TO: Planning Commission

FROM: Ben Shumaker, Short Plat Administrator

SUBJECT: Proposed Short Plat (SP2022-03)

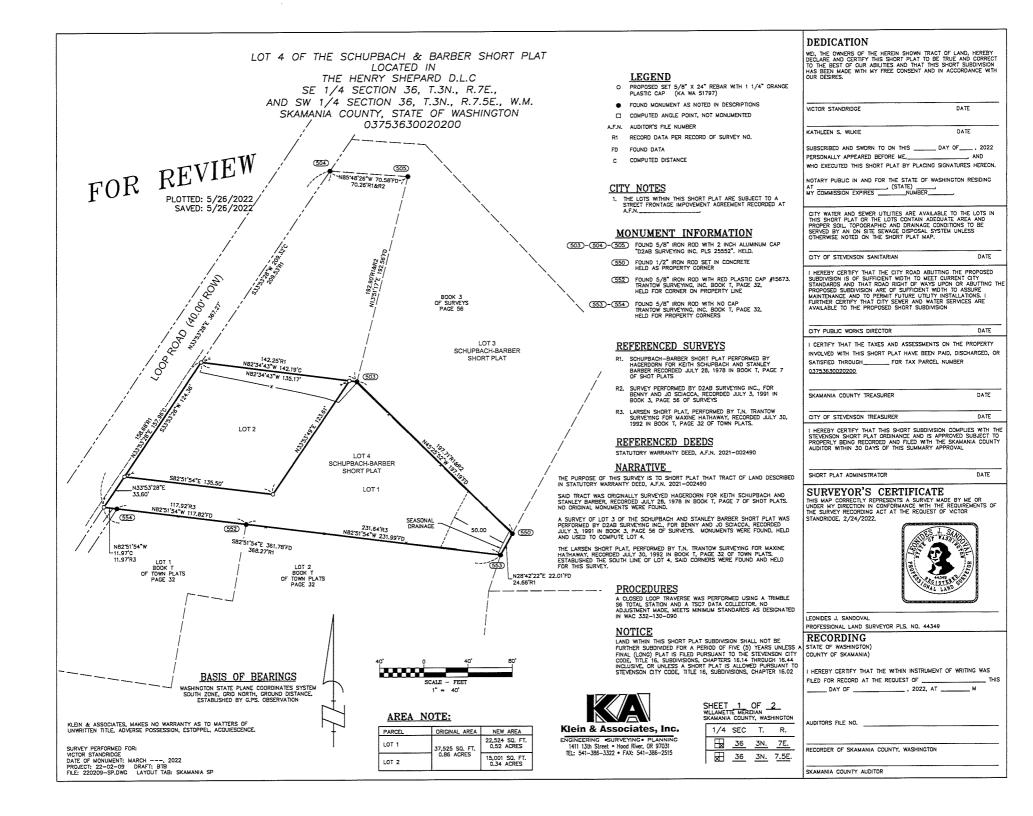
REPORT: Staff received verbal comments from Gerald Larsen, an adjacent landowner. The property is located immediately south and down-gradient from the proposal. The comments related to the proposed use of septic systems and the subsurface flow of water which is believed to be very shallow. Colorful parts of the description involve water coming out of mole hills. He relayed multiple times his desire not to derail the project. He also supplied the attached map showing where there is a shallow well and where groundwater interacts with the foundation of the home.

INVESTIGATION: Staff investigated this issue by calling the Skamania County Environmental Health Department responsible for septic reviews. Nikki Rohan, the health officer described the septic permitting process and the approval issued for this proposal. Details discussed included the water percolation tests performed, the lack of standing water in the test holes, and water's general tendency to go downward, not laterally. The health officer also discussed the project with Mr. Larsen but saw insufficient reason to reconsider the approval.

- 1- Make no recommendation on the proposal and entrust the decision to the administrative officials.
- 2- Recommend including a requirement to connect to City sewer when available.
- 3- Recommend including a requirement to connect to City sewer when available and a requirement to participate in the cost of the extension.
- 4- Recommend immediate extension and connection to the City sewer system.
